**RE: NOTICE OF DISAPPROVAL FOR THE INVESTIGATION WORK PLAN FOR  
SOLID WASTE MANAGEMENT UNIT 21-017(a)-99, MATERIAL DISPOSAL  
AREA U, AT TECHNICAL AREA 21  
LOS ALAMOS NATIONAL LABORATORY (LANL), EPA ID #NM0890010515  
HWB-LANL-04-015**

The New Mexico Environment Department (NMED) is in receipt of the *Investigation Work Plan for Solid Waste Management Unit 21-017(a)-99, Material Disposal Area U, at Technical Area 21*, dated November 2004 and referenced by LA-UR-04-7268 (ER2004-0569). NMED hereby issues this Notice of Disapproval of the aforementioned Work Plan. The Department of Energy and the Regents of the University of California (collectively the "Permittees") must respond to all comments as outlined in this letter within thirty (30) days of receipt of this letter.

Figure 4.2-1. Proposed borehole locations at MDA U

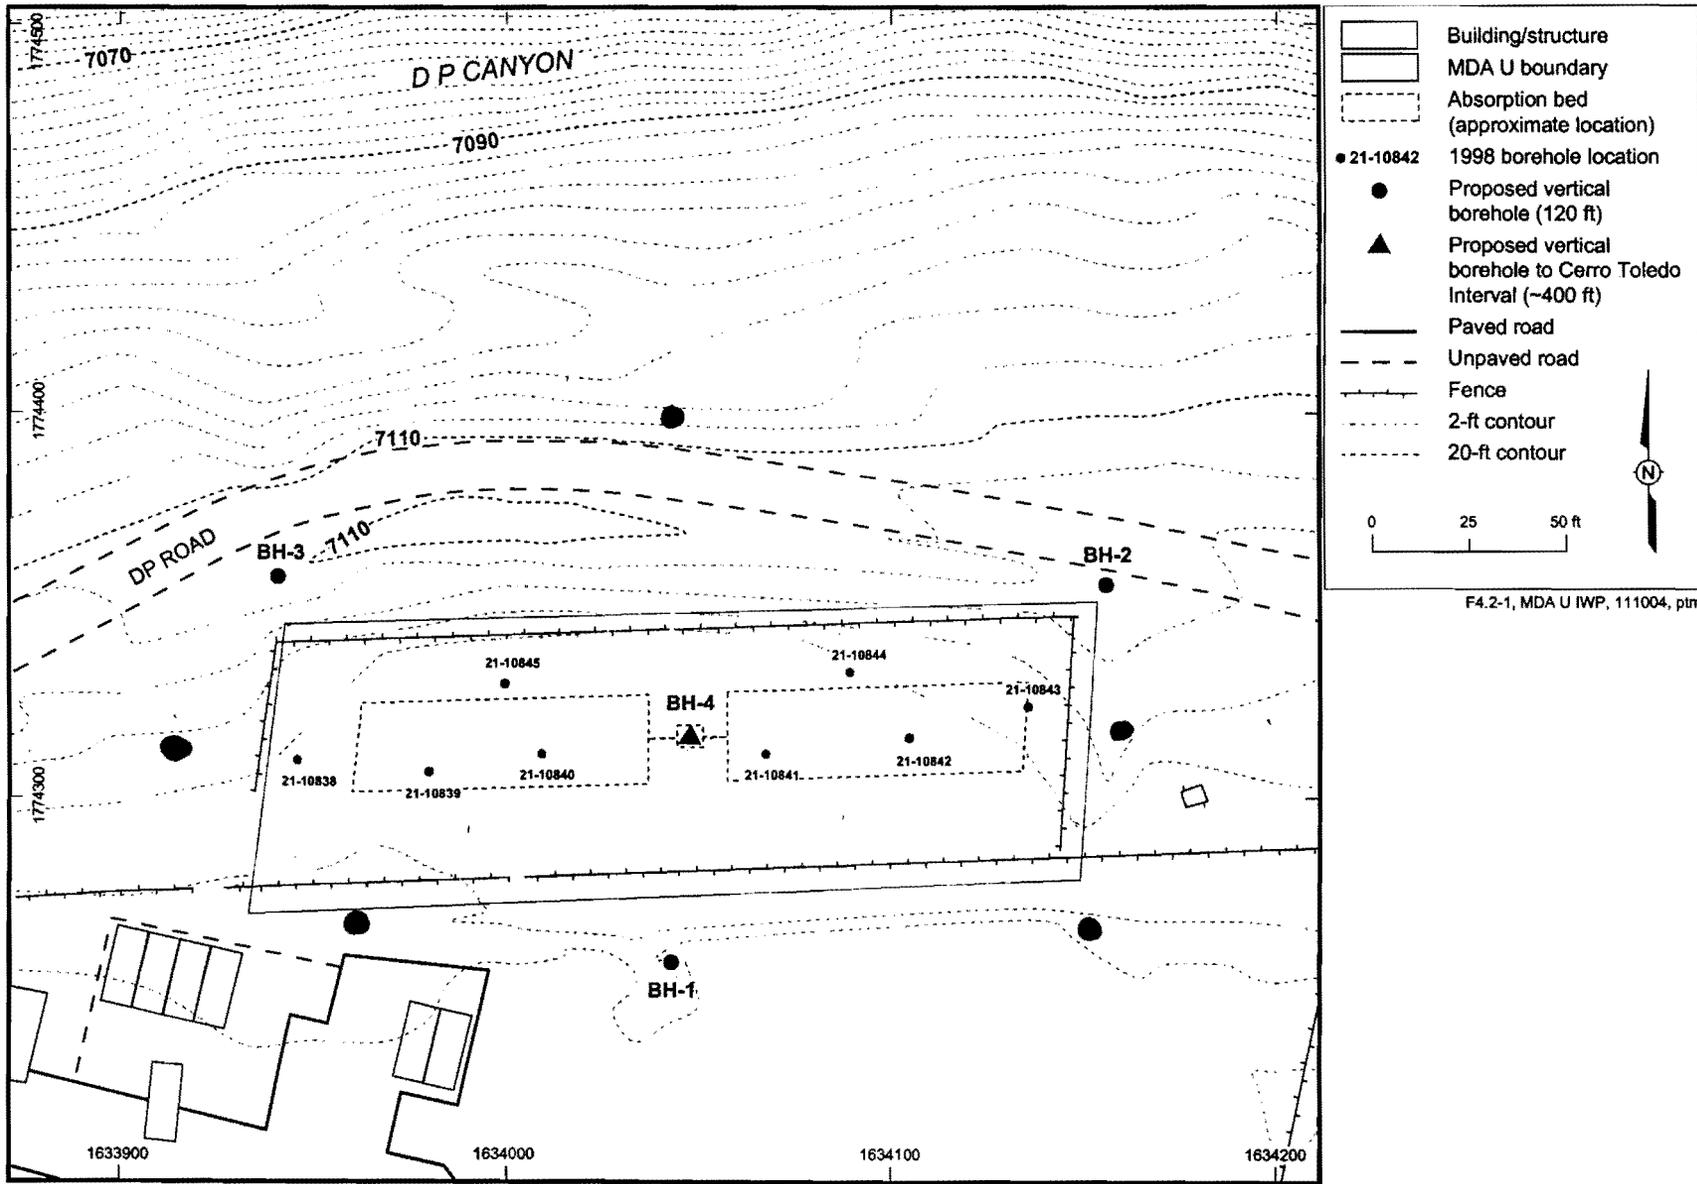
Based on information provided in the HIR, the Permittees identified soil and vegetation contamination outside the MDA U fenceline in 1980 and 1984. Also, the extent of the fractured/clay interbed zone has not been defined and is a potential contaminant migration pathway. Based on this information, the Permittees must complete the additional boreholes

at the locations identified by NMED (see attached map) to determine lateral and vertical extent of contamination. If contamination is found in any of the boreholes, the Permittees must use a 'step-out' approach to determine lateral extent of contamination.
